Received by NCD: \$/19/2024 10:30:53 AM U.S. Department of the Interior BUREAU OF LAND MANAGEMENT		Sundry Print Report 03/19/2024
Well Name: SILVER FED COM	Well Location: T20S / R33E / SEC 16 / TR A / 32.580084 / -103.66147	County or Parish/State: LEA / NM
Well Number: 124H	Type of Well: OIL WELL	Allottee or Tribe Name:
Lease Number: NMNM094851	Unit or CA Name:	Unit or CA Number:
US Well Number: 3002551290	Well Status:	Operator: MATADOR PRODUCTION COMPANY

Sundry ID: 2776118

Silver #124H API 30-025-51290 – Remediation Procedure

Silver #124H API 30-025-51290: Remediation – Actual Results

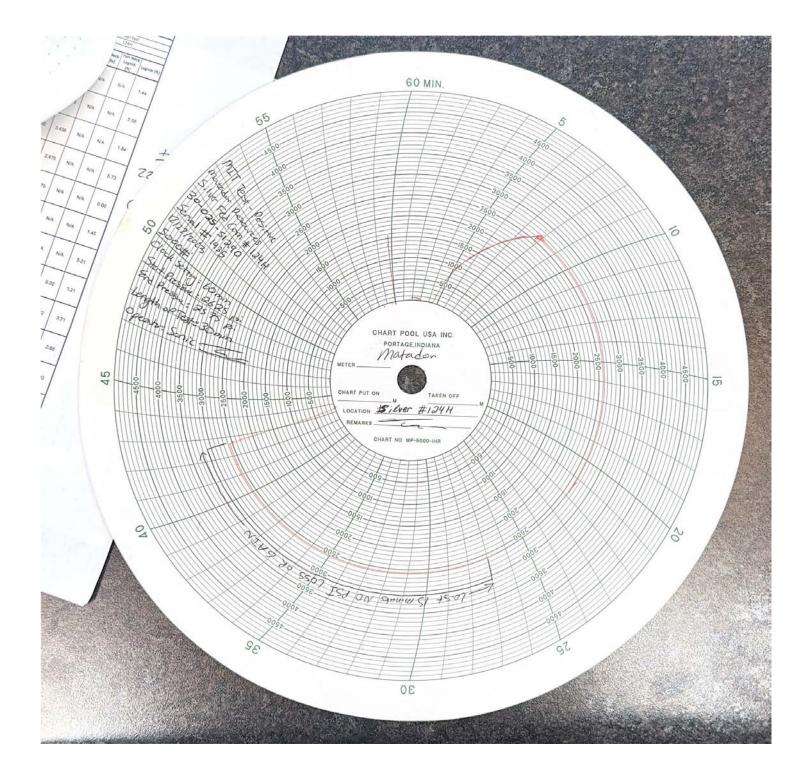
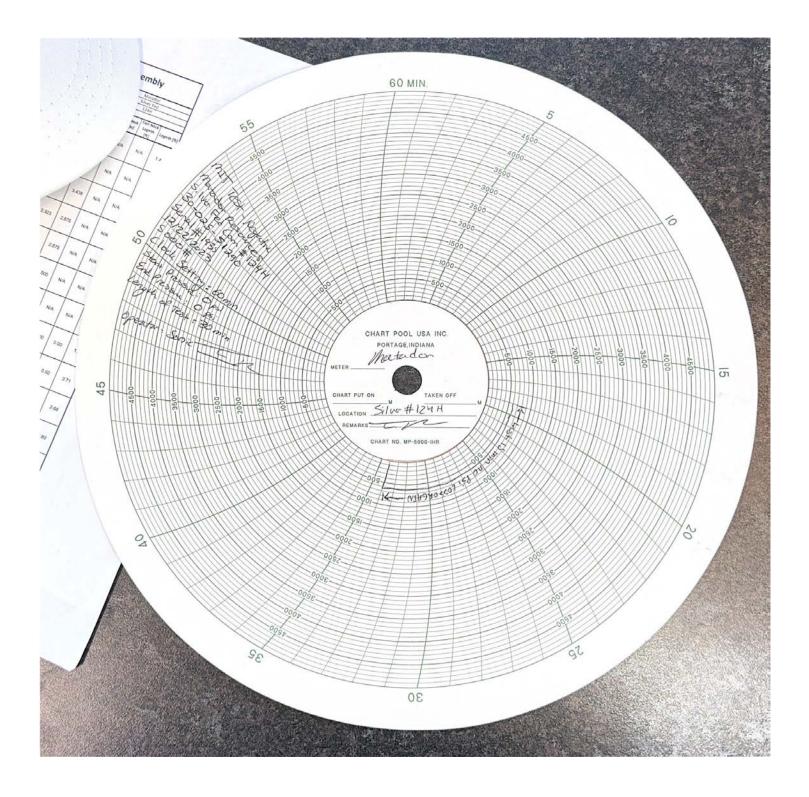
Heel Hardline: 10,491' MD

Lease Line Intersection: 10,389' MD

New First Take Point: 10,712' MD

- 1. MIRU workover rig and all auxiliary equipment. Kill well and ensure WHP = 0 psi before proceeding.
- 2. Cleanout well with Coretrax string mill BHA to ~10,792' MD.
- 3. Set correlation bridge plug (BP) at 10,705' MD.
- 4. Cleanout well with Coretrax string mill BHA #2 to ~10,700' MD.
- 5. Set expandable liner from 10,690' MD to 9,769' MD.
- Perform positive pressure test on wellbore and liner from correlation BP to surface at 2,600 psi for 30 minutes, good test *chart attached.
- 7. Perform negative pressure test on wellbore and liner from correlation BP to surface for 30 mins, good test *chart attached.
- 8. Mill correlation bridge plug.

New First Take Point: 10,712' (221' MD inside Heel Hardline and 323' MD inside Lease Line)
